UNITED STATES PATENT AND TRADEMARK OFFICE

10/581,415

Office Action Summary	Application No. 10/581,415	Applicant(s) MAIER ET AL.	
	Examiner MACADE BROWN	Art Unit 3753

DETAILED ACTION

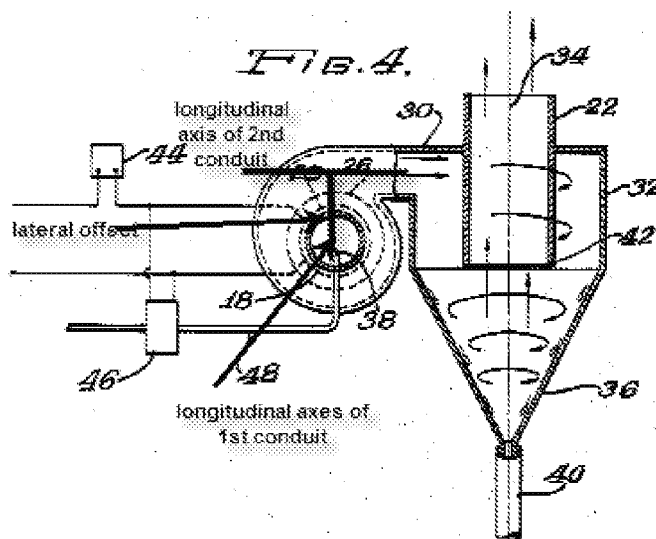
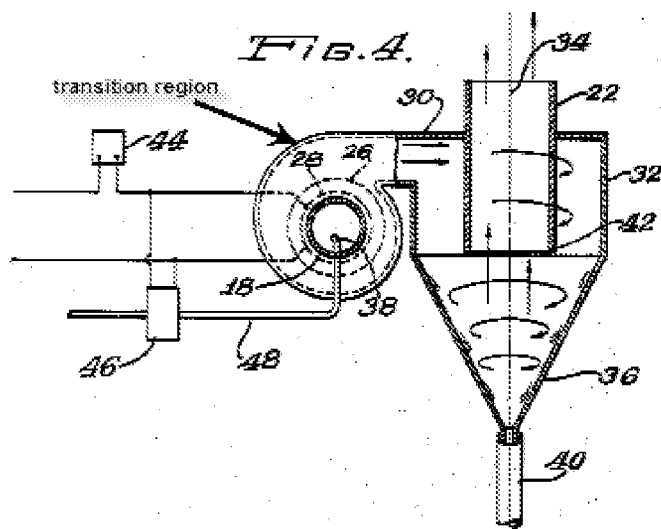
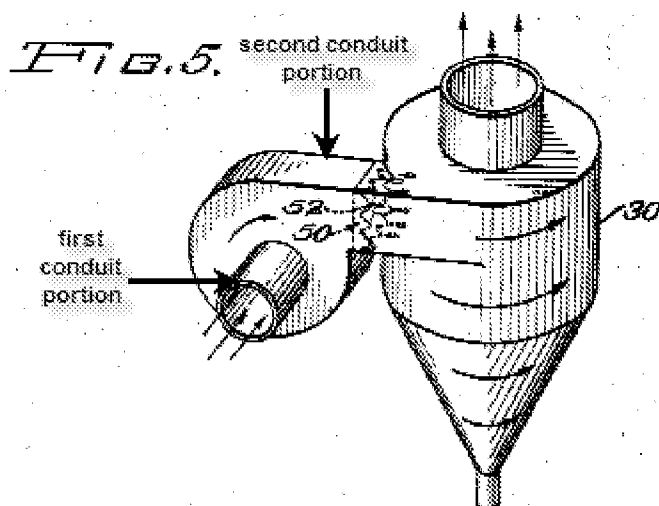
Regarding claims 10-12, and 16-27, Nozaki teaches an inlet valve assembly including a valve element 42 (fig. 4) disposed in a valve chamber 32 and fluid conduit (conduit formed by 18 and the lateral extension of duct 30; see fig. 5 below) adjoining the valve chamber 32 on the upstream side, wherein the fluid conduit has a substantially constant width and is embodied such that a rotation about the longitudinal axis of the fluid conduit is impressed on the fluid stream that flows toward the valve chamber, without a constriction of this fluid stream being produced; wherein the fluid conduit includes a first conduit portion 18 and a second conduit portion (fig. 5 below) adjoining the first conduit portion 18, the longitudinal axes of the first and second conduit portions being at an angle < 180 [deg.] to one another, and the longitudinal axis of the first conduit portion 18 being laterally offset from the longitudinal axis of the second conduit portion; wherein the longitudinal axes of the first and second conduit portions are at least approximately at a right angle to one another (see fig. 5); wherein the first and second conduit portions, in cross section, have at least approximately the same radius, and wherein the lateral offset of the longitudinal axes is greater than the radius (see 4 below); further including a transition region (see fig. 4 below) between the first conduit portion 18 and the second conduit portion (Note: the patentability of a

964,966 (*Fed. Cir. 1985*)); wherein the transition region includes a wall that is curved

from the first conduit portion 18 to the second conduit portion; wherein the first conduit

portion 18 extends no more than an axially insignificantly distance past the second

conduit portion.
